June 11, 1984

Re: McGuire Nuclear Station
Docket Nos. 50-369, 50-370

DUKE POWER COMPANY
McGUIRE NUCLEAR STATION
SPENT FUEL POOL RERACK MODIFICATIONS
ADDITIONAL INFORMATION

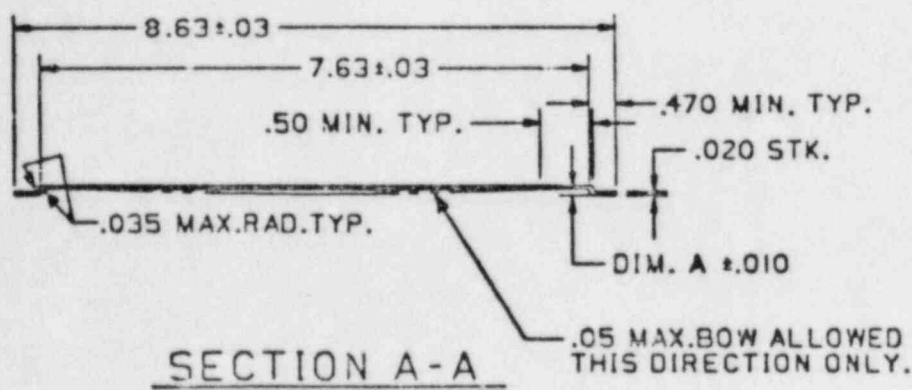
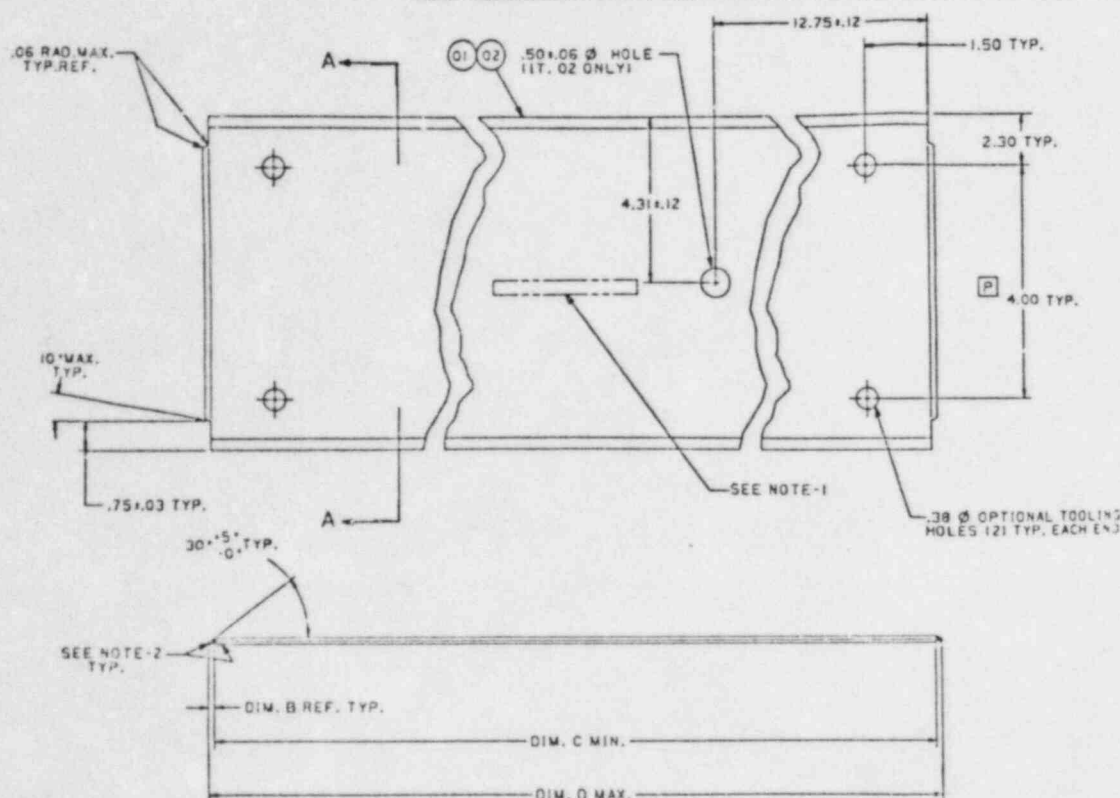
As detailed in the attached sketch, each set of 3 coupons is to be mounted between two 75 mil stainless steel plates. This arrangement closely resembles that of the boraflex mounted on the rack cells. Wrapper and cell material is also 75 mil stainless.

MC GUIRE NUCLEAR STATION, UNITS 1 & 2 SPENT FUEL RACKS - WRAPPER PLATES

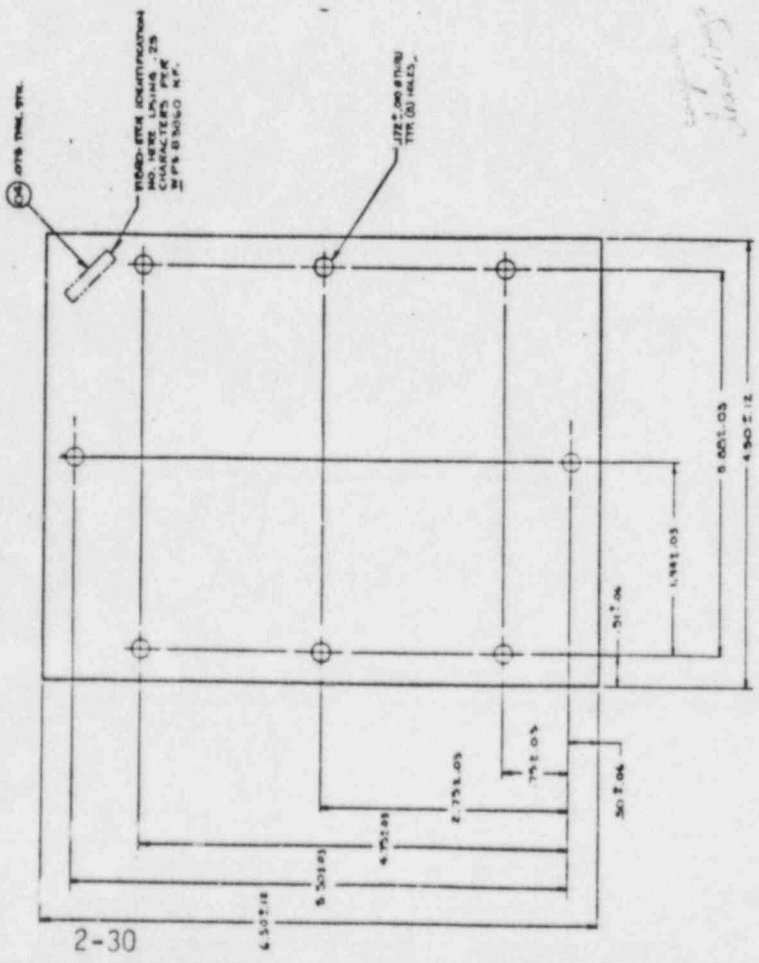
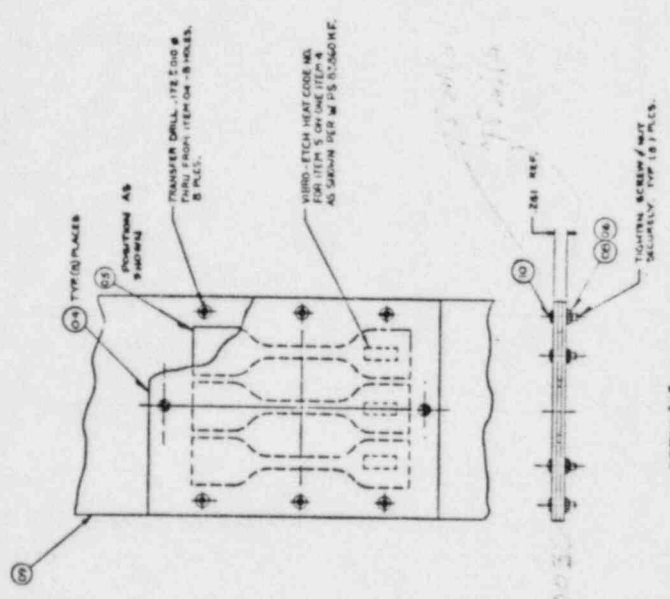
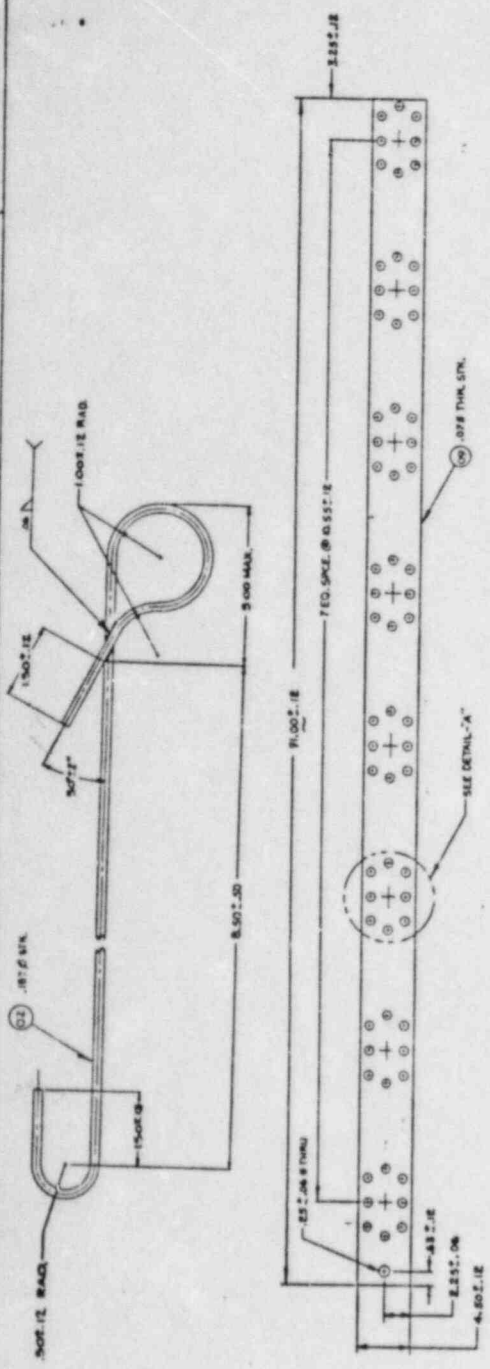
A sketch of the wrapper plate details is included as Attachment 1.

2. Poison material venting occurs through cutouts at corners of the wrapper plate. The wrapper is spot welded to the cell wall along the vertical joint between the wrapper and cell.
3. There has been no change in the spent fuel pool water boron concentration. The proposed technical specification changes include a surveillance requirement to verify boron concentration once per 31 days. The boron concentration in the spent fuel pool is to be maintained at greater than or equal to 2000 ppm.
4. Details of the McGuire neutron poison surveillance program are as follows:
